SOIL/SITE EVALUATION
for ON-SITE WASTEWATER SYSTEM

Re: Application for improvement permit for Richard Hagemeyer
Property Site: lot 4, Kalabash Road
Health Department file no. 4865B

Re: Detailed Soil/Site Evaluation on a ±10.0acre site (Lots 1 – 10) on the corner of Harbor View and Kalabash Roads, Mecklenburg County, NC.

SHEET 1 OF 1	SHEET TITLE: DETAILED SOILS EVALUATION	PROJECT NAME: R.H. HEGEMEYER, INC. – HARBOR VIEW – MECK. COUNTY, NORTH CAROLINA MAY 2002	S&EC Soil & Environmental Consultants, PA

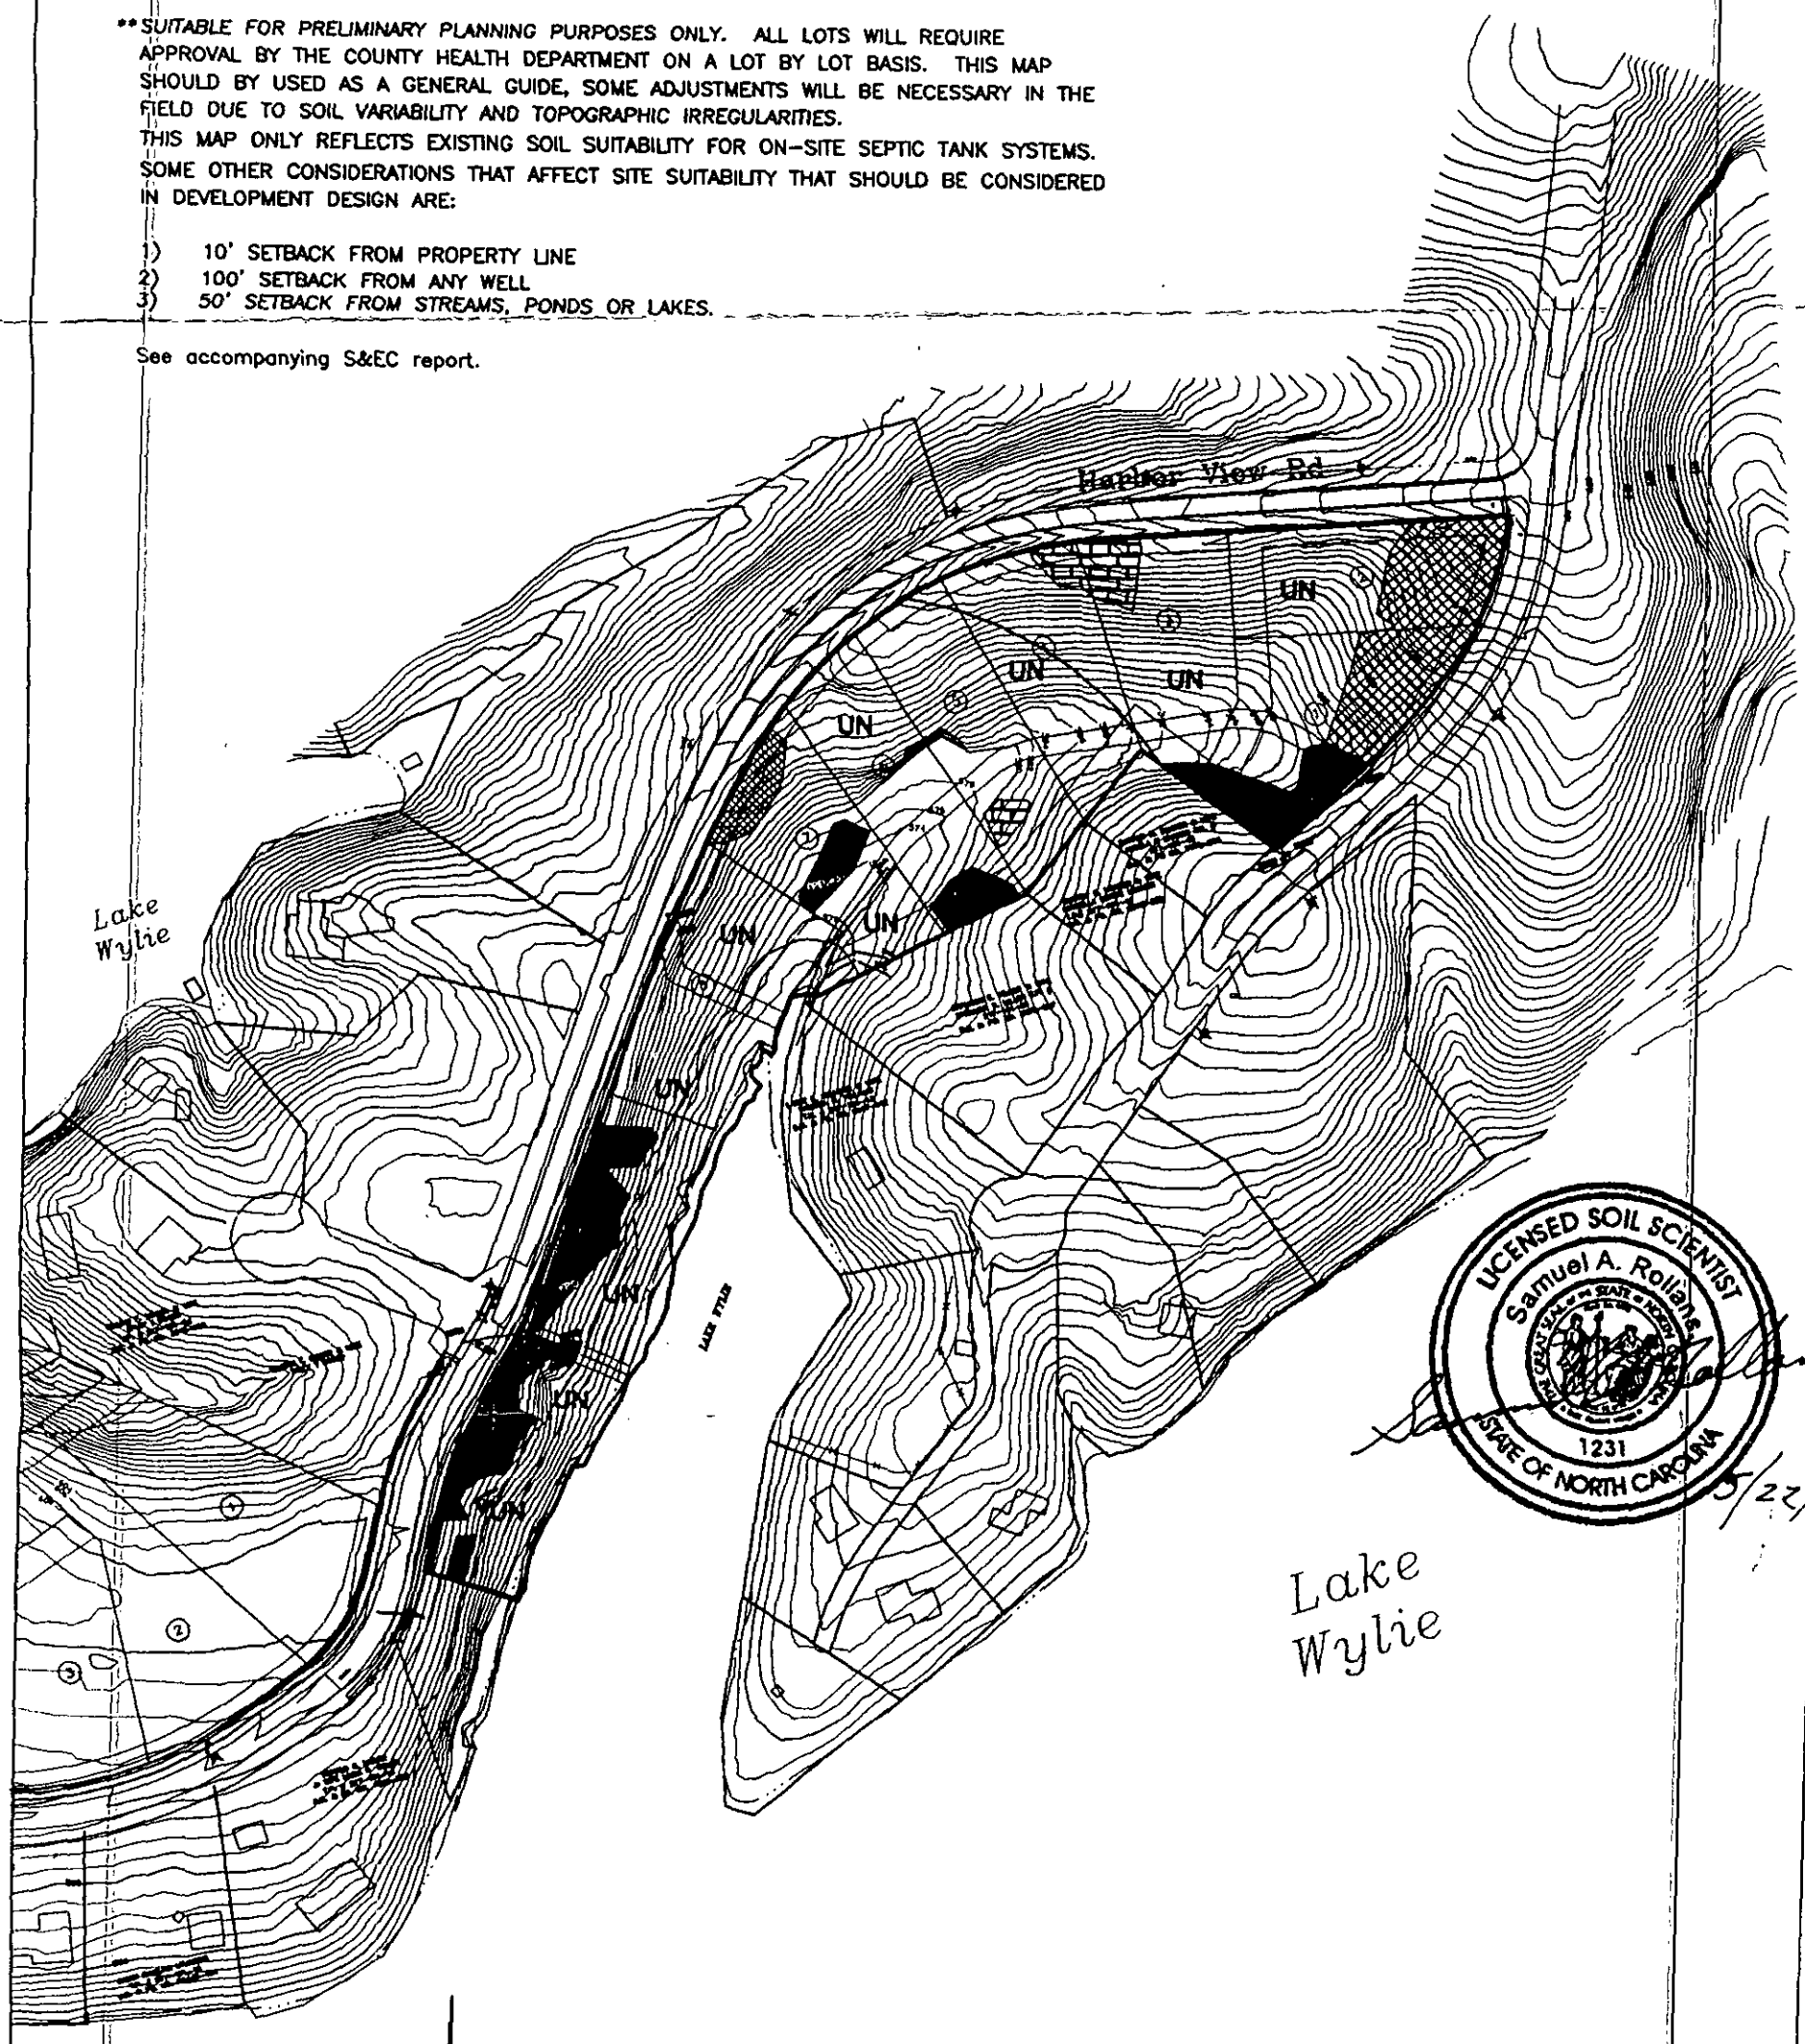
The accompanying *GPS/AutoCAD* map indicates the areas with potential use for subsurface wastewater disposal. The **"Solid-Hatched"** units indicate areas of soils that are at least 30 inches deep to prohibitive soil characteristics and have potential for conventional and modified conventional (shallow placed lines with no fill required over the disposal area) septic systems. The **"Diamond-Hatched"** units indicate areas of soils that are 24 to 30 inches deep to prohibitive soil characteristics and have potential for low pressure pipe system (LPP) and/or ultra-shallow conventional (shallow placed lines with fill required over the disposal field) system. The **"Block-Hatched"** units indicate areas of soils that are 18 to 24 inches deep to prohibitive soil characteristics and have potential for subsurface drip irrigation w/pretreatment septic systems. Such systems typically cost in excess of $15,000.00 to $20,000.00 +. The **"UN"** units on the attached map indicate soil areas with less than 24 inches to unsuitable characteristics and generally unsuitable for systems mentioned above.

** *SUITABLE FOR PRELIMINARY PLANNING PURPOSES ONLY.* ALL LOTS WILL REQUIRE APPROVAL BY THE COUNTY HEALTH DEPARTMENT ON A LOT BY LOT BASIS. THIS MAP SHOULD BY USED AS A GENERAL GUIDE, SOME ADJUSTMENTS WILL BE NECESSARY IN THE FIELD DUE TO SOIL VARIABILITY AND TOPOGRAPHIC IRREGULARITIES.
THIS MAP ONLY REFLECTS EXISTING SOIL SUITABILITY FOR ON-SITE SEPTIC TANK SYSTEMS. SOME OTHER CONSIDERATIONS THAT AFFECT SITE SUITABILITY THAT SHOULD BE CONSIDERED IN DEVELOPMENT DESIGN ARE:

1) 10' SETBACK FROM PROPERTY LINE
2) 100' SETBACK FROM ANY WELL
3) *50' SETBACK FROM STREAMS, PONDS OR LAKES.*
